OREGON WATER RESOURCES DEPARTMENT

Revised Proposed Final Order on the Potential for Cumulative Impacts Dorena Lake Dam Hydroelectric Project HE 559

Cumulative Impacts Review)
For Hydroelectric Application HE 559) **Revised**
At Dorena Lake Dam) **Proposed Final Order**
Symbiotics LLC, Applicant) **on Cumulative Impacts**

Figure 4. Average daily storage for Dorena Lake from 1990 to 2002. Average daily outflows for the same period measured at USGS Gage No. 14155500 near Cottage Grove, Oregon. (Source: ERI and NW Power Services, 2004a, as modified by staff)

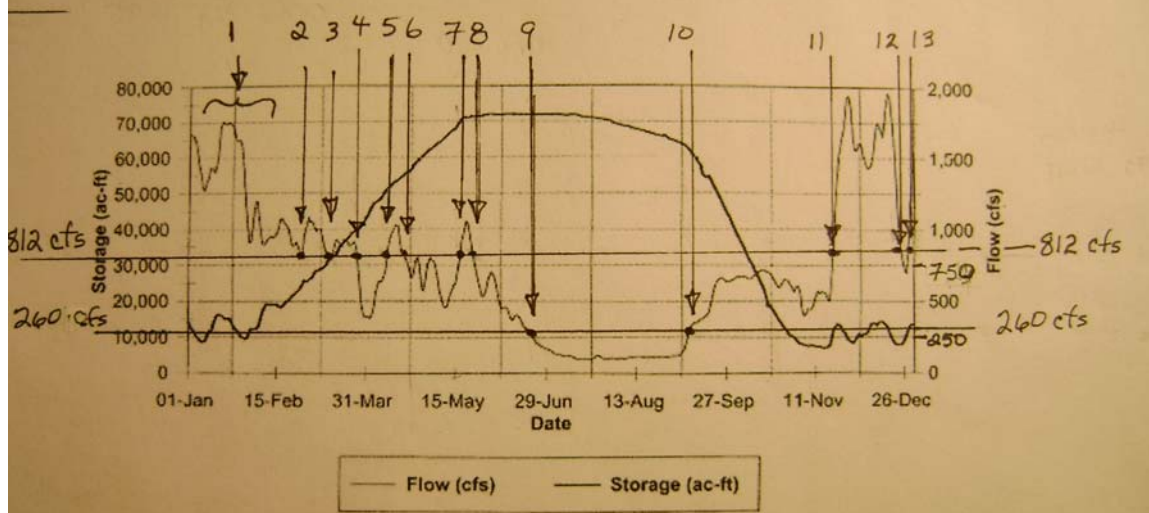
First let's notice this graph comes from FERC application, September 1, '06 page 28. The handwritten numbers at the top of this graph are highlighting the intersections of flow rates (cfs) to horizontal lines of the maximum 812 cfs and the minimum 260 cfs for the turbine facility. In the #1 area, the flow rate is high enough to meet the maximum level of the turbine and the excess flow is diverted through the existing floodgates. As the flow rate decreases, some of the existing floodgates are being closed and sediment naturally accumulates in front of these gates. As we reach the flow rate at position # 2, all existing floodgates are closed (allowing sediment to accumulate in front of all such gates) and only the penstock is open. As we move across the graph, the increase in flow rate causes the existing floodgates to be opened. Upon this opening, a large initial 'slug' of sediment is transported downstream due to the fact that all floodgates have been previously closed.

Figure 4 – Dorena Reservoir Temperature Profiles

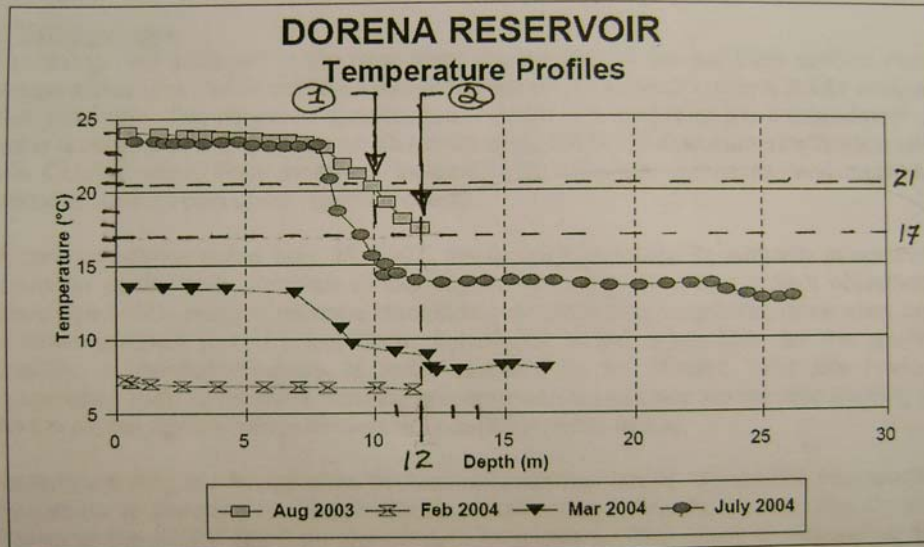
2. Having a clear picture of this new penstock design, we now have an issue with the 7 to 10 foot increase in elevation above the existing floodgates regarding the change in temperature. By using the data graph of temperature, we can look at water depth and see how temperature is depth sensitive during critical times of the year. The picture below is from page 23 of the draft 401 document.

It shows the temperature of four different sample times; August, February, March, and July. In the August and February data, it looks as if the deepest sample available (due to low lake levels) is about 12 meters of water. By the location of the three sample sites, I will assume it is a representative 'average' (?) of the temperature strata found in similar locations near the floodgates. The graph of the August sample implies that going from a depth of 10 meters to a depth of 12 meters will change the temperature by 4 degrees centigrade. Note the handwritten numbers of 1 and 2 showing the temperatures of 21 degrees and 17 degrees at the corresponding depths of 10 and 12 meters. The difference of 2 meters could have the same affect (change of 4 degrees) with the new penstock design being elevated by 7 to 10 feet. This has serious implications on all biological communities downstream and assumptions made in the 401 draft document. Needless to say that the Row River/Dorena Dam is on temperature watch and this will cause further degradation of downstream biological communities.

Comments received from John Steele raised the issue of whether the Project would cause increased temperatures downstream during July and August. Mr. Steele referred to a Figure 4 – Dorena Reservoir Temperature Profiles (pg 23, ODEQ Evaluation and Findings Report, Jan 2008) of August 2003, February 2004, March 2004, and July 2004. The profiles show water temperatures that decline in March, July, and August as measured from surface level to lower depths in the

reservoir. In July and August, when the reservoir is at full pool, the intake pipe is at a depth of more than 20 meters below the surface of the water. The temperature profiles show that between depths of 10 to 12 meters the temperature levels decline rapidly and then are uniform from depths of 12 meters to 25 meters. Therefore, neither the size of the intake pipe, nor its placement near the floor of the reservoir will cause variation in outlet temperatures during July and August. Temperature variations are expected when the reservoir mixes or “destratifies” in late fall. Waters in the lake will be of fairly consistent temperature when the lake levels are low during the winter and early spring months.
